# Service Bulletin

**RRP Service Bulletin No:** RRP SB367

**Title:** Turntable Rework

**Product Series:** Advanced Tie Plate Inserter

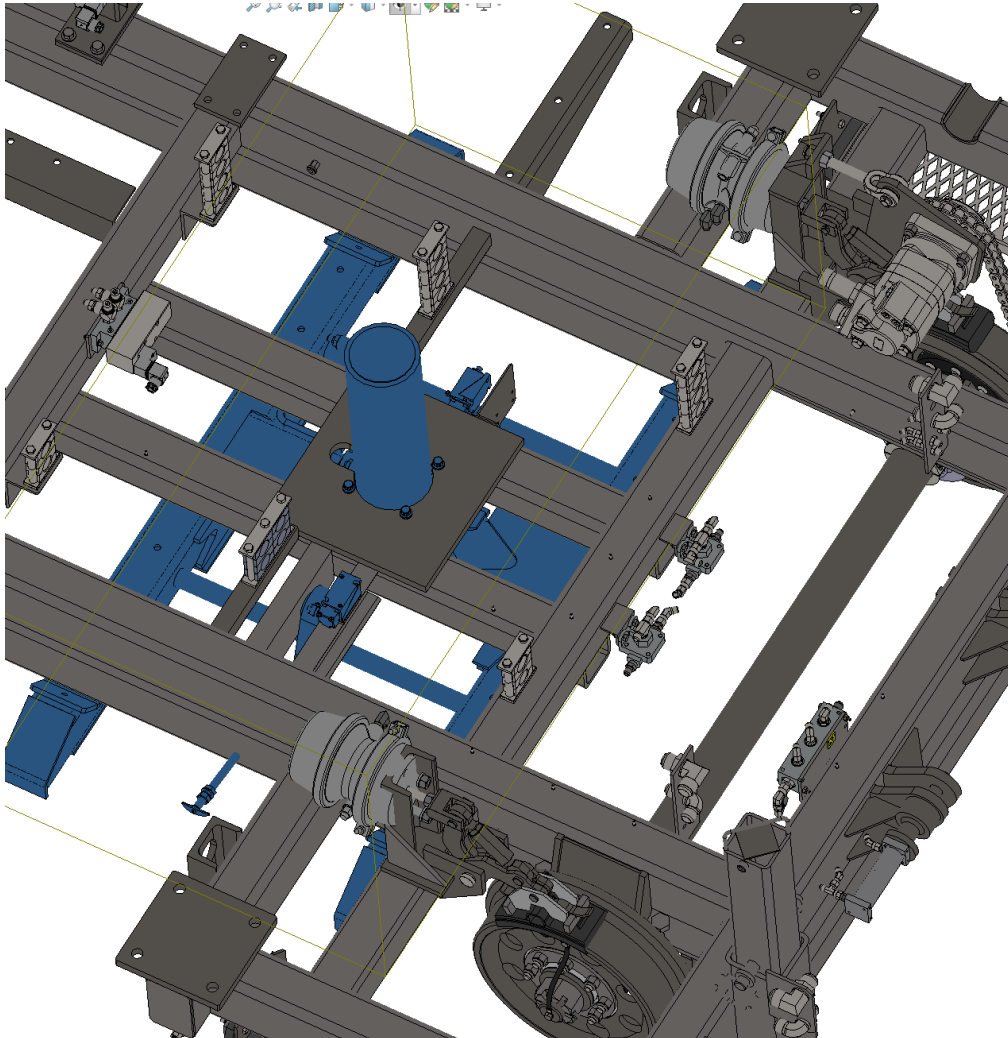
**Summary:** The turntable is off-centered with the machine center of gravity and can cause machine imbalance when raising the machine.

**Resolution:** Machine rework to reposition the turntable to the proper center of gravity location should be done at the RRP factory in Mt. Pleasant, Wisconsin.

**Action:** *Turntable use is not recommended until correction is applied. However, the turntable can be used a minimum height if necessary.*

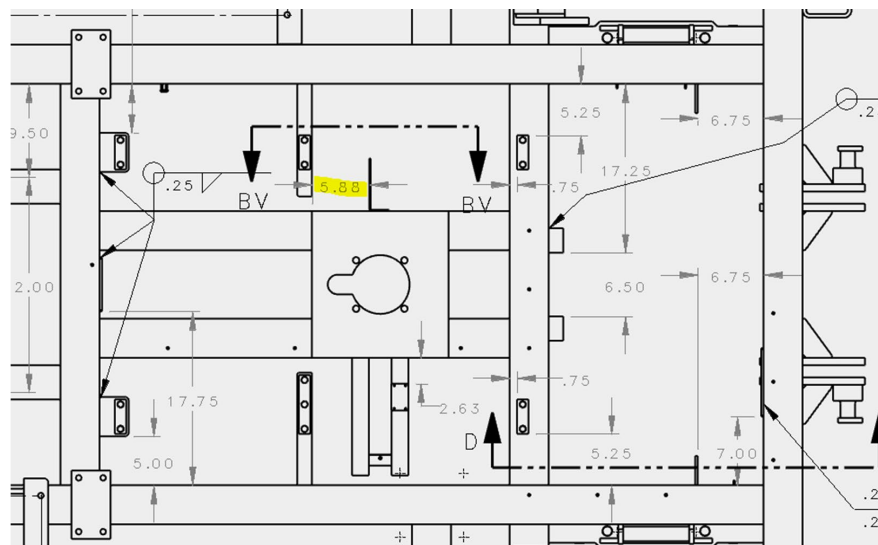
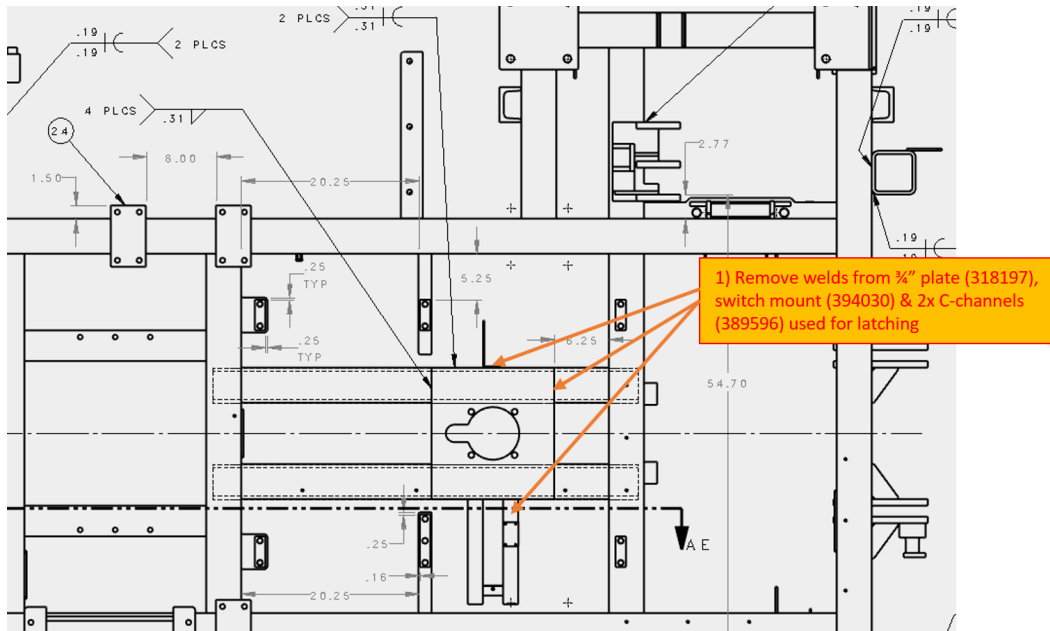
7. Remove welds from 3/4" plate (RRP# 318197), switch mount (RRP# 394030), and 2 x C-channels (RRP# 389596) used for latching.

**Note:** Removing the weld may cause damage to existing machine plate, latches, switch mount, and C-channels.

8. Cut off main turntable pad

-Reinstall turntable pad to the new specified dimension by welding.

-Reinstall limit switch brackets and hook brackets to new dimension by welding. New brackets may be necessary depending on their condition after removal.
